Service Advisory

W-125

Models: 13A4616G190 (LT 1650), 13A6616H190 (LT 1850)

Subject: COLD ENGINE STARTING

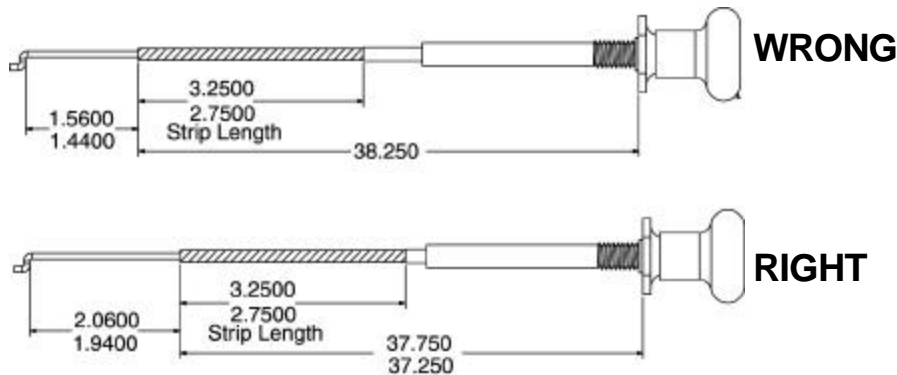
PROBLEM: Reports from the field indicate that cold engine starting problems have been occurring on some 2003 tractors with the twin cylinder White Outdoor engine (Tecumseh).

CAUSE: Tractors built in January 2003 may have the wrong choke cable.

SOLUTION: Check the choke circuit. In the CHOKE/START position, make sure the choke shutter* is closed. If the choke shutter is closed, continue troubleshooting. If the choke shutter is not closed, compare the choke cable on the tractor with the illustrations below.

If the cable is wrong, remove/discard the wrong choke cable and replace with part number 746-1085A.
